Access Compliance Report Public Rights-of-Way (Curb Ramps)

Main Street: SIENNA_PKWY Cross Street: N_DAISSY_ST Location: S

ADA ID: RPRK211110124843 Ramp Type: Type 1 - Perpendicular Initial Pass/Fail: Fail Overall Compliance: No Severity Score: 15

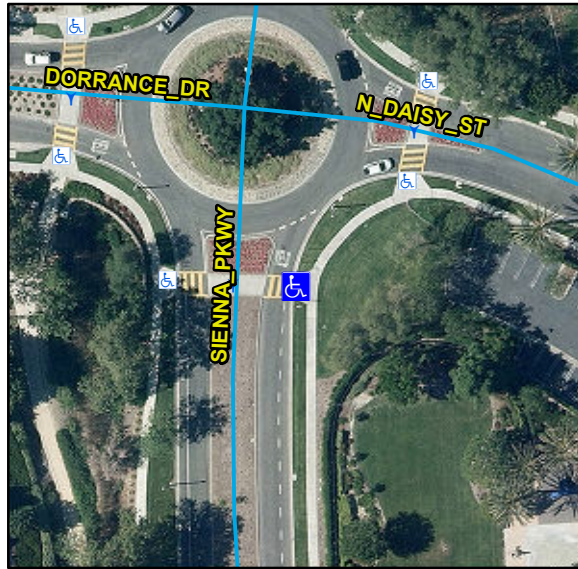
Compliance	Description	Data	Compliance	Description	Data
N/A	Ramp Length (in)	86	N/A	Flare Type LT	
Yes	Ramp Width (in)	48			N/A
No	Ramp Run Slope (%)	10.8	N/A	Flare Slope LT (%)	N/A
Yes	Ramp Cross Slope (%)	0.7	N/A	Flare Traversable LT	N/A
N/A	Landing Present	N/A	N/A	Flare Type RT	
N/A	Landing Length (in)	N/A			N/A
N/A	Landing Width (in)	N/A	N/A	Flare Slope RT (%)	N/A
N/A	Landing Run Slope (%)	N/A	N/A	Flare Traversable RT	N/A
N/A	Landing Cross Slope (%)	N/A	N/A	DWS Provided	N/A
N/A	Landing Movement Obstructed?	N/A	N/A	DWS Contrast	N/A
	Landing Movement Type	N/A	N/A	DWS Length (in)	N/A
N/A	Landing Shared	N/A	N/A	DWS Full Width	N/A
N/A	Clear Space	N/A	N/A	DWS Offset Left (in)	N/A
N/A	Clear Space To Crosswalk (in)	N/A	N/A	DWS Offset Right (in)	N/A
N/A	Marked Crosswalk 1	Yes	N/A	Marked Crosswalk 2	N/A
	Crossing 1 Direction	W		Crossing 2 Direction	N/A
	Marked Crosswalk 1 Width (in)	144		Marked Crosswalk 2 Width (in)	N/A

N/A	Ramp Inside Crosswalk 1	Yes	Yes	Ramp Inside Crosswalk 2	N/A
	Crossing 1 Slope (%)	2.8		Crossing 2 Slope (%)	N/A
	Crossing 1 Cross Slope (%)	0.1		Crossing 2 Cross Slope (%)	N/A
N/A	Gutter Ponding	N/A	No	Curb Slope	9.3
Yes	Gutter Lip Height (in)	0		Road Run Slope (%)	N/A
N/A	Gutter Run Slope (%)	N/A		Road Cross Slope (%)	N/A
N/A	Gutter Cross Slope (%)	N/A			
Yes	Overall Surface Condition: Acceptable		No	Perp Joint Present	No
	Cross Gutter Present?	No		Spandrel Present?	No
	Replace Cross Gutter?	N/A		Replace Spandrel?	N/A

Remove & Replace Entire Ramp.

R304.2.2, R204.3, STD 1115
